STATE OF ALASKA

DIVISION OF MINING AND WATER MANAGEMENT

INSPECTION REPORT BETTY KRUTZSCH MINE F986842

Inspection Date: September 14 & 15, 1998
Next Inspection Date: Spring 1999
Land Status: Private
Land Owner: Alaska Gold Company; Betty Krutzsch
Operator: Betty and August Krutzsch
Agency Personnel: Ryan Hull, DMWM
Inspection Objectives: Determine necessary action to avoid further water quality degradation; inspect reclamation and directives that were to occur prior to this inspection.
Note: See attached daily notes, sketches and photos for additional details.

ETCH OF OPERATION

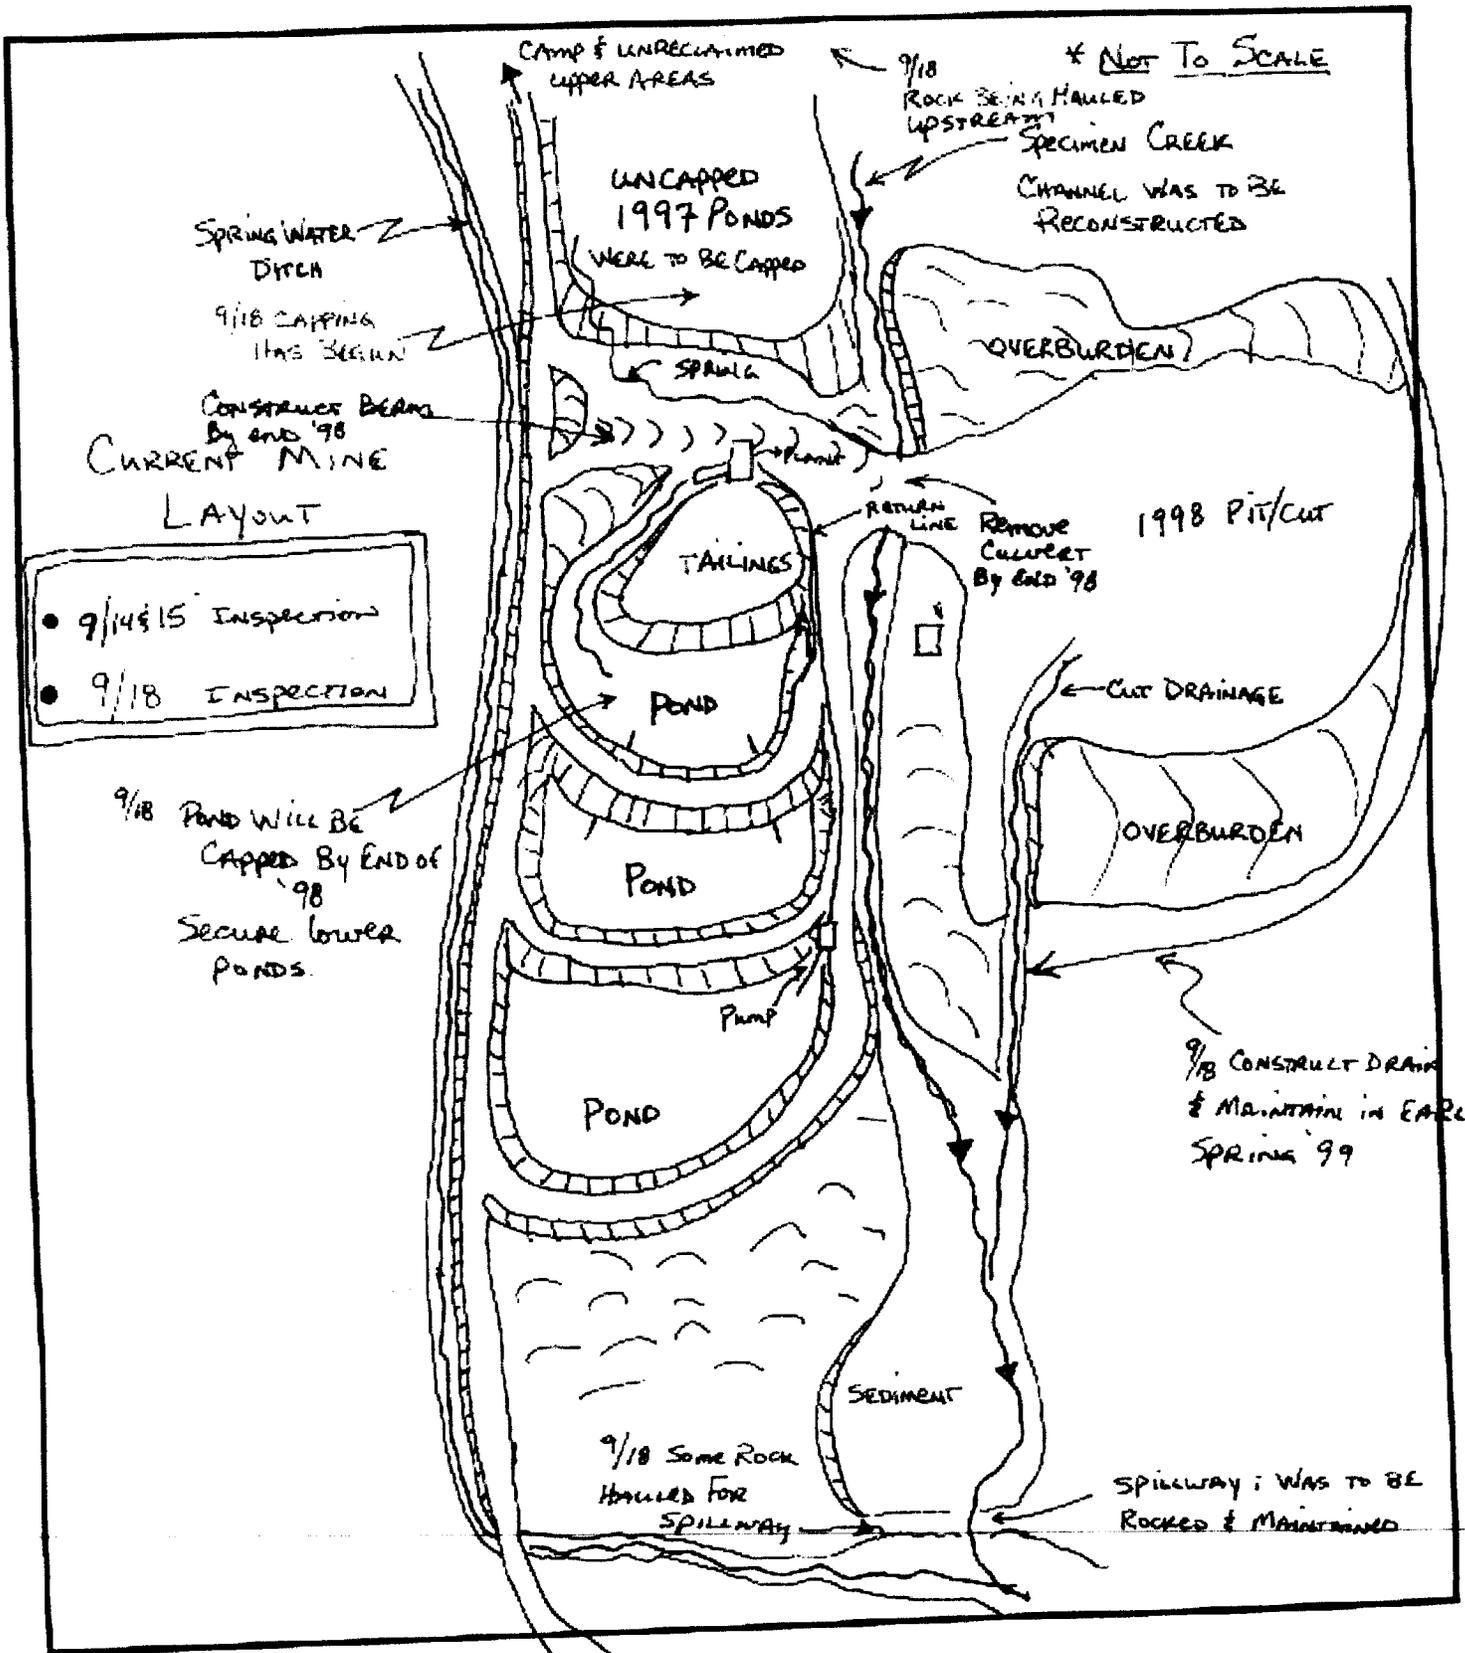
- *1- CONSTRUCT STREAM CHANNEL THROUGHOUT ENTIRE OPERATION.
 - a) CONSTRUCT ACCORDING TO FISH & GAME GUIDELINES
 - b) FOLLOW EXISTING MEANDER PATHS - WHERE POSSIBLE
 - c) DO NOT PUSH LEFT OR RIGHT OVERRBURDEN PILES TOWARD STREAM UNTIL STREAM CHANNEL IS CONSTRUCTED & EXHIBITS REASONABLE STABILITY.
- 2- CONSTRUCT DRAINAGE CHANNELS AS NECESSARY IN AREAS WITH POTENTIAL FOR EXCESSIVE EROSION * ESPECIALLY AROUND CAPPED PONDS.
- *3- CAP REMAINING 1997 PONDS. CAP WITH ENOUGH MATERIAL TO ENSURE POND SECURITY; PROVIDE DRAINAGE TO AVOID EROSION.
- 4- CAP ALL PONDS USED FOR 1998 PROCESSING
- 5- REINFORCE ENTIRE LENGTH OF STREAM CHANNEL; ESPECIALLY AROUND CAPPED POND AREAS
- 6- COMPLETE DRAINAGE CONTROLS AROUND AREAS OF GREATEST EROSION POTENTIAL. (CHECKDAMS)
- 7- CONSTRUCT & MAINTAIN SPILLWAY ON LOWEST RECLAIMED DAM.
